# **Tutunup Titanium Minerals Mine**

**Cable Sands (WA) Pty Ltd**

**Report and recommendations  
of the Environmental Protection Authority**

**Environmental Protection Authority  
Perth, Western Australia  
Bulletin 1085  
December 2002**

Figure 2: Mine layout (Source: CSWA, 2002)

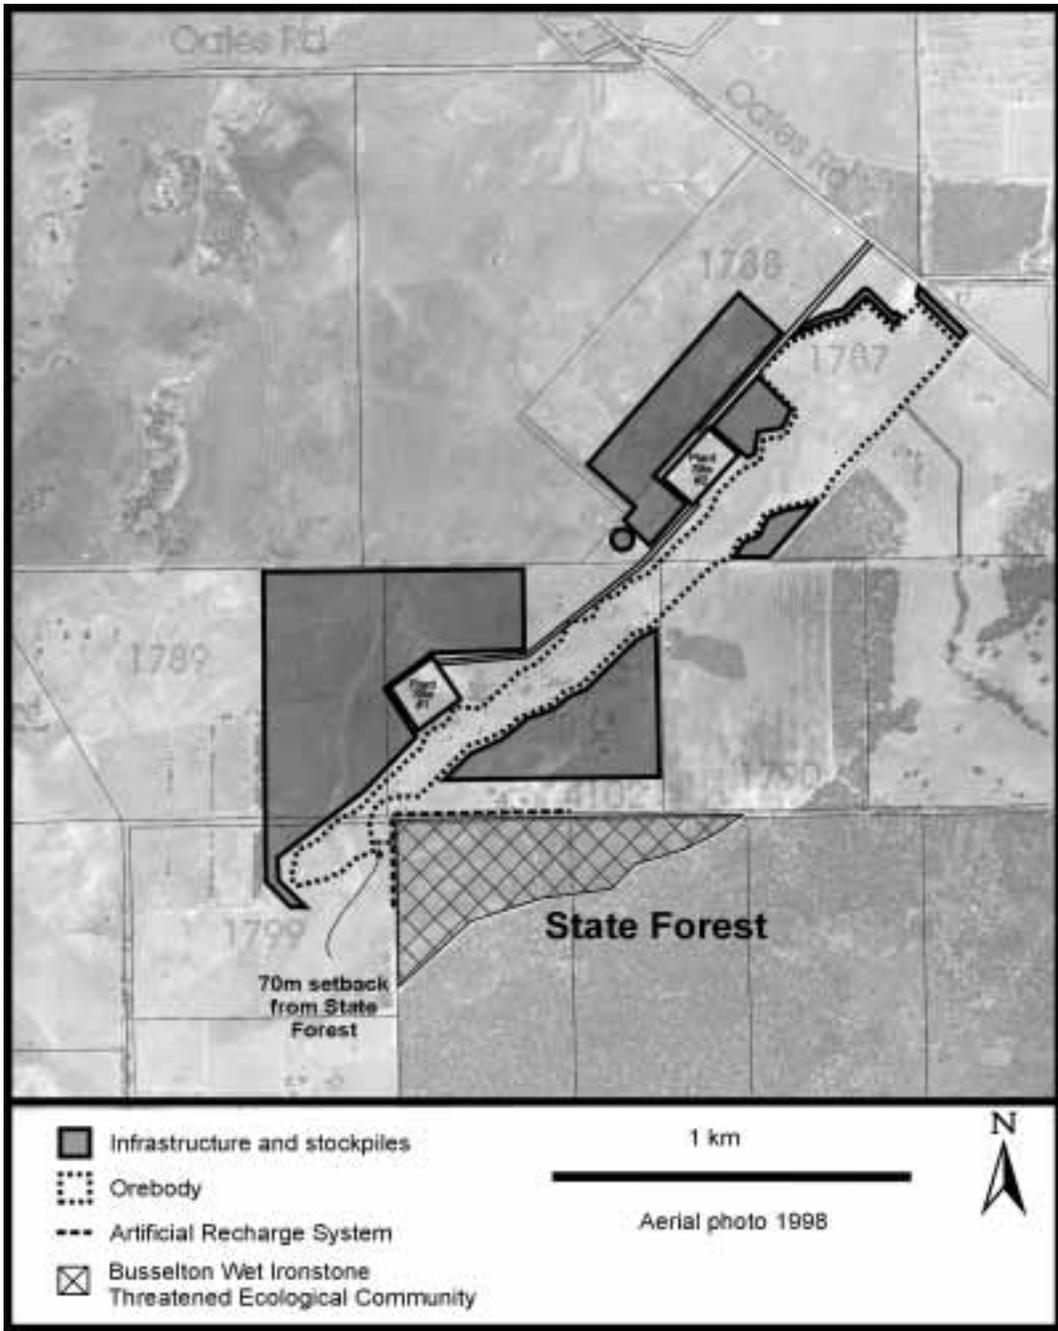
- provision of a 70 metre setback/buffer between the mining area and the TEC (previously 20 m) (see Figure 2);
- project life now approximately 4 years in total and 27 months of mineral production;

<sup>1</sup> The groundwater in the area naturally flows northwest from the TEC towards the proposed mining area (see Figure 2). The artificial recharge system aims to maintain the natural water-level fluctuation of the superficial aquifer, in the vicinity of the TEC in the adjacent State Forest. (The significance of the superficial aquifer is discussed further in Section 3.2).

The area considered for assessment of this factor includes the area covered by the southern portion of the mine pit, and the Busselton Wet Ironstone TEC that occurs in State Forest immediately east of the Tutunup deposit (see Figure 2).

Figure 3: Conceptual mine plan (Source: CSWA, 2001 as amended, Nov 2002)

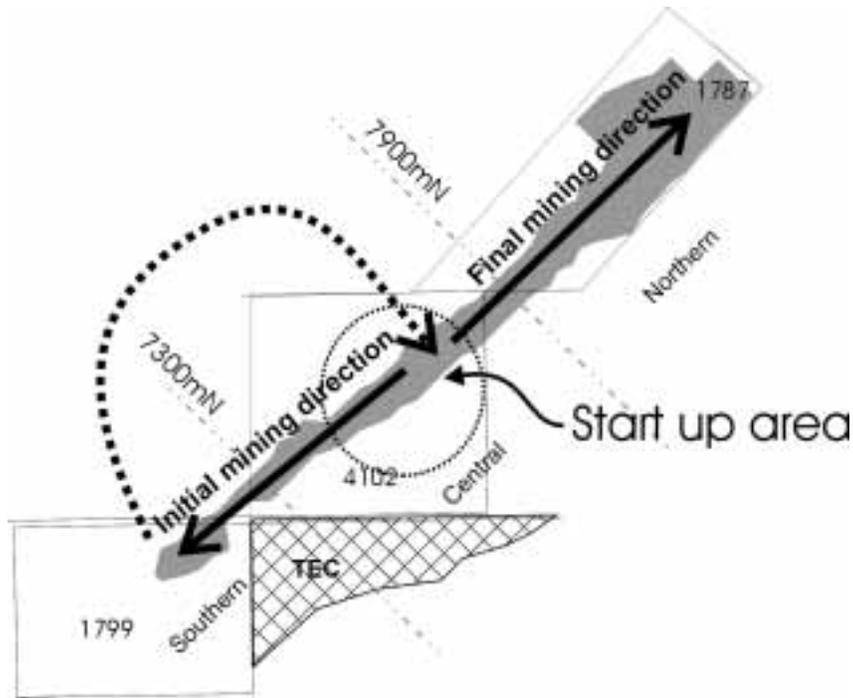
The proponent has made a number of modifications to the proposal since release of the PER document. These include:
